ADDENDUM #2

Project: Ogden-Hinkley Airport
Front Terminal Expansion

Project Manager: Steven Lund AIA
Project Number: 2021-10
Date: 7.19.24

E401B

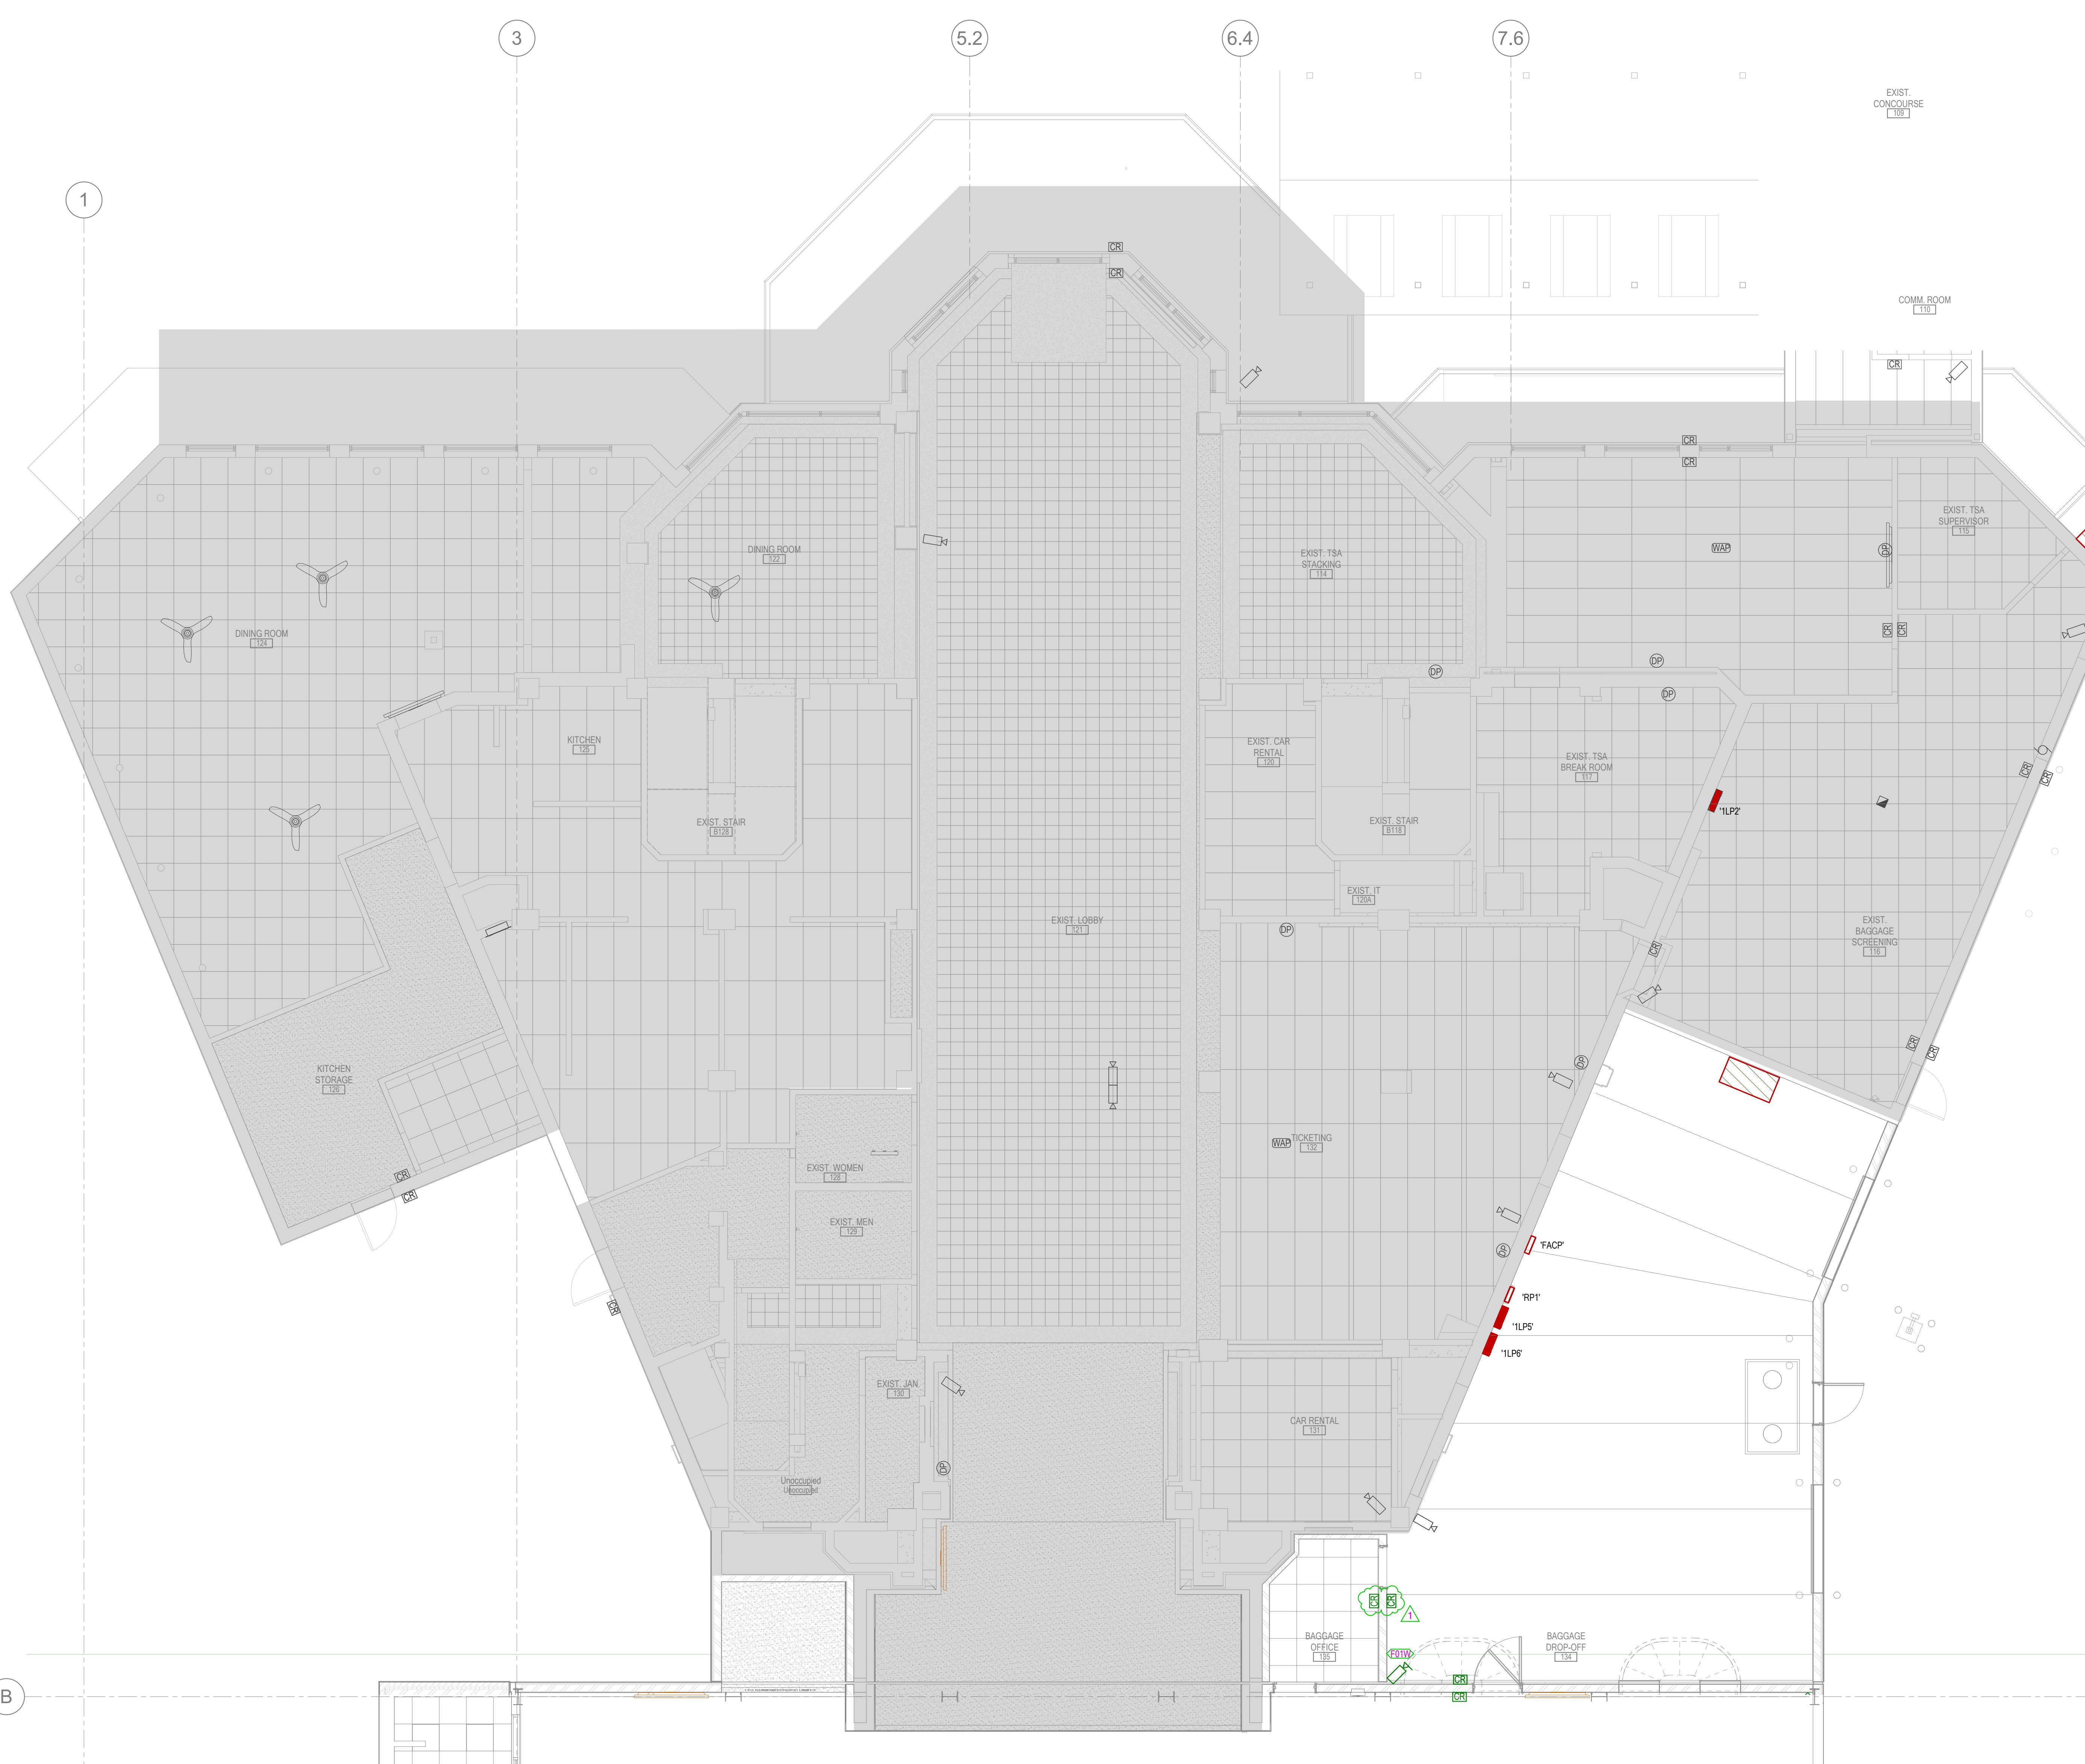
10. SHEET E401B

- a. Add card readers.

E401C

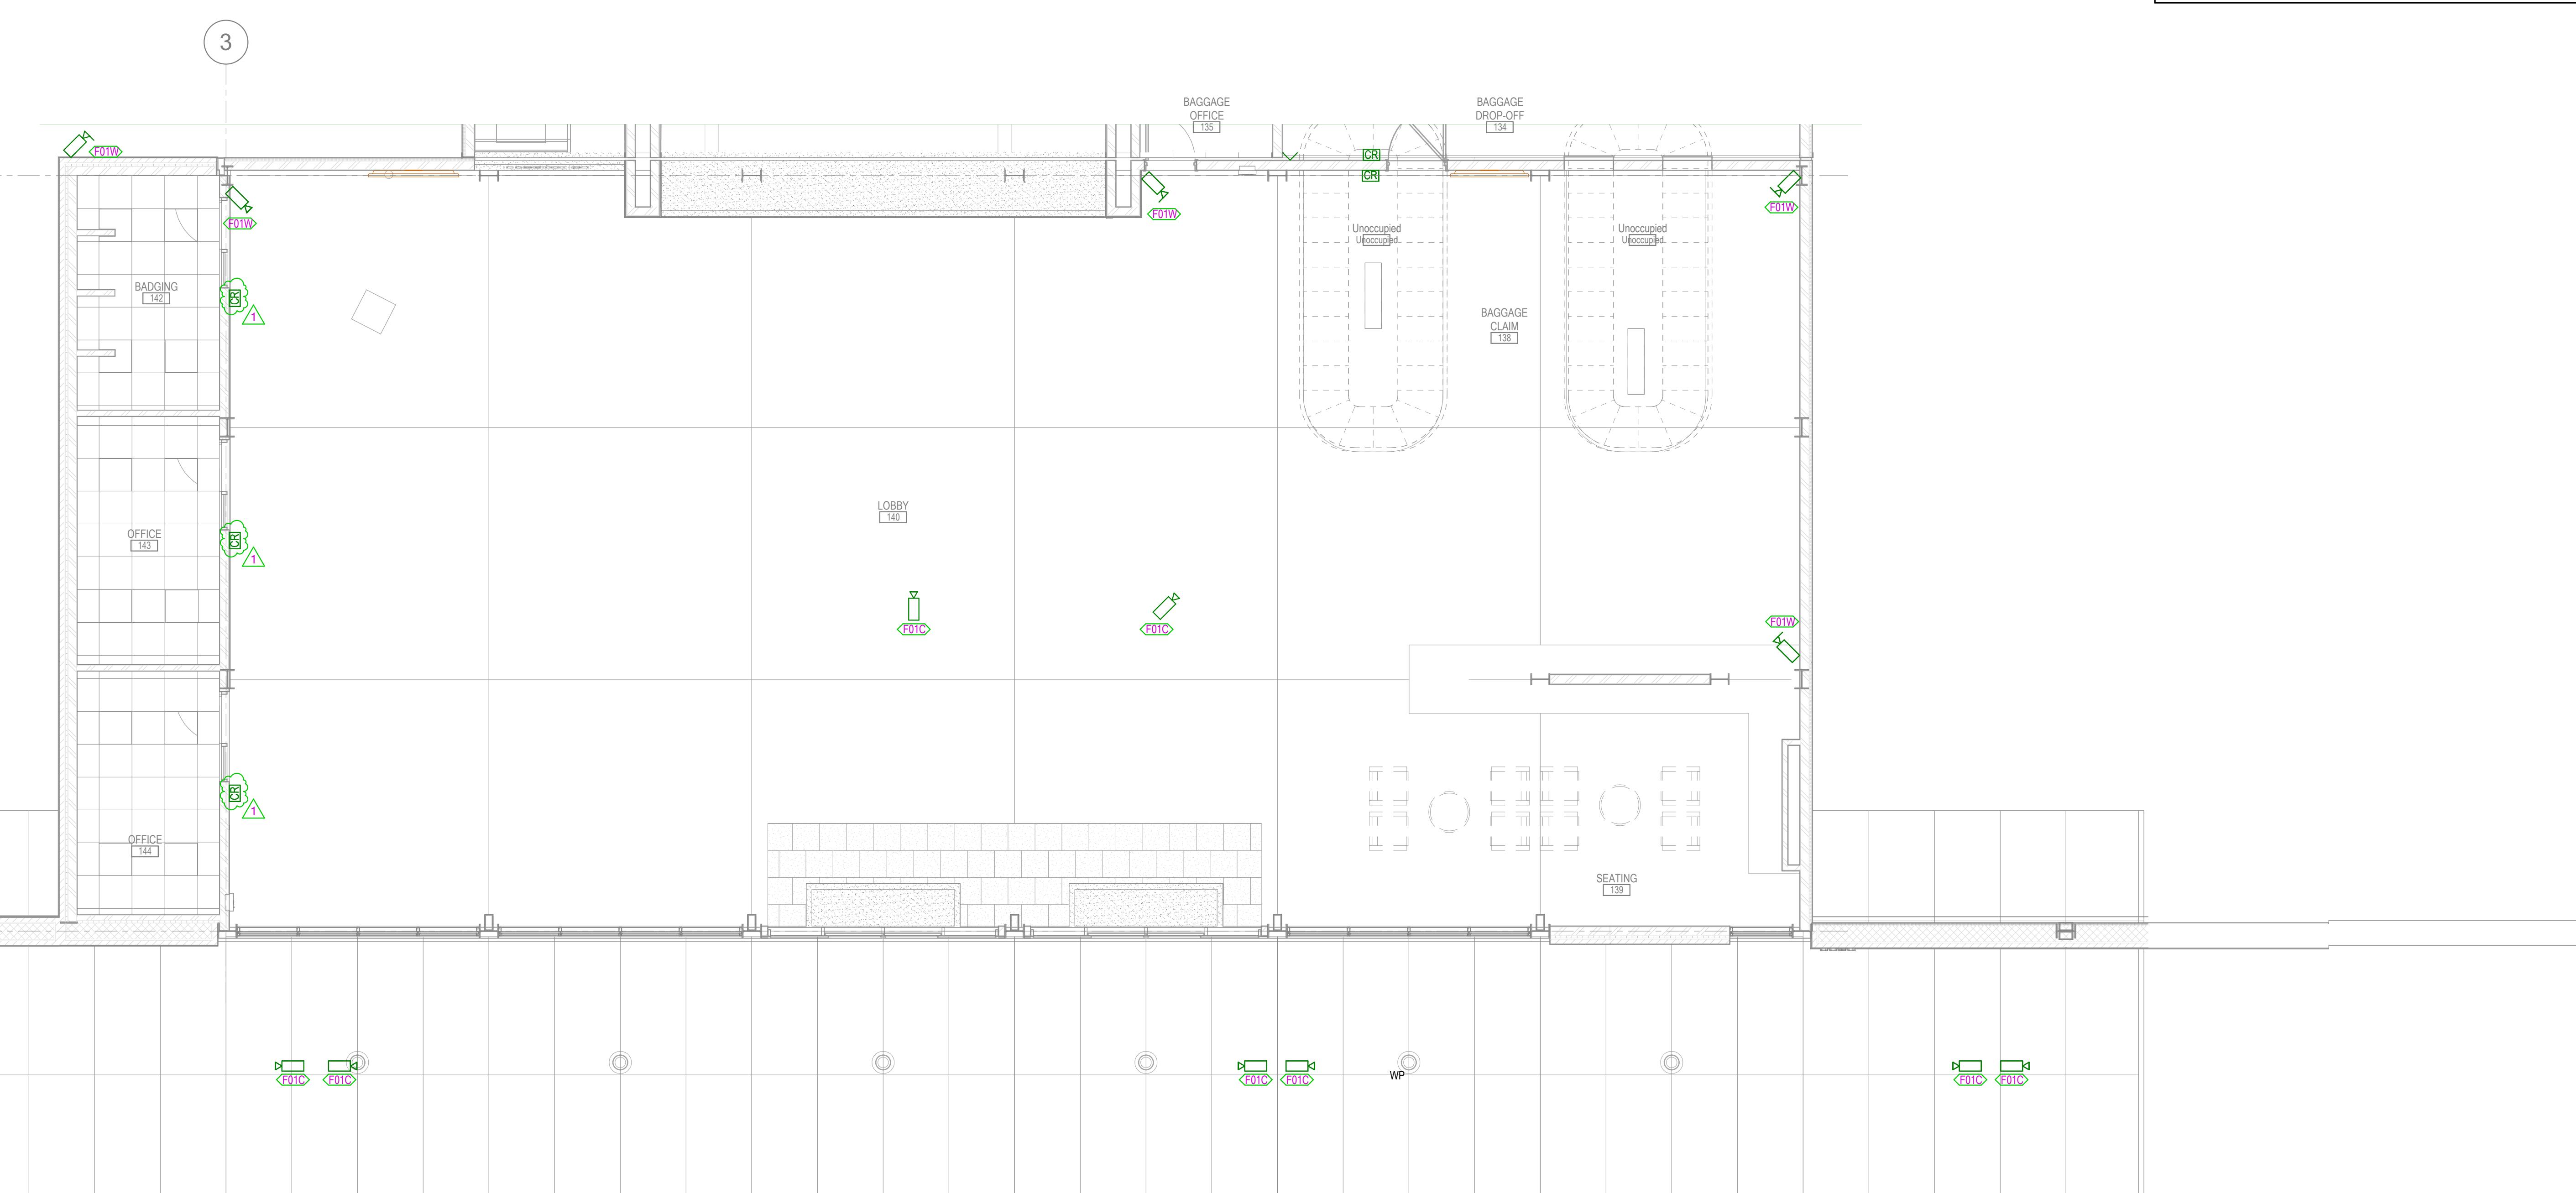
11. SHEET E401C

- a. Add card readers.
